803 WEST 12TH AVENUE (PRELIMINARY APPLICATION)
DE416467 - ZONE CD-1

DEVELOPMENT PERMIT STAFF COMMITTEE MEMBERS

DEVELOPMENT PERMIT STAFF COMMITTEE RECOMMENDATION: APPROVE IN PRINCIPLE

SITE PLAN | SCALE 1:250

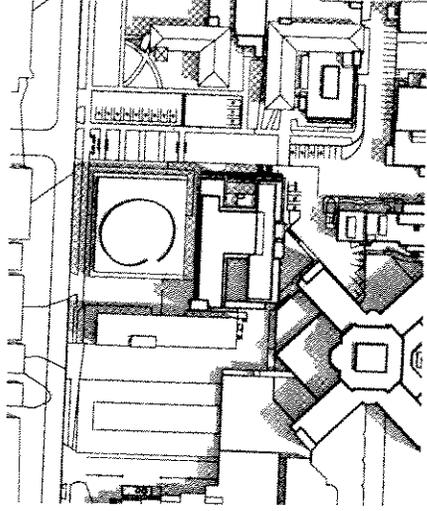
iii. clarification of the note on sheet L-1, "grades to be lowered inside dashed line";
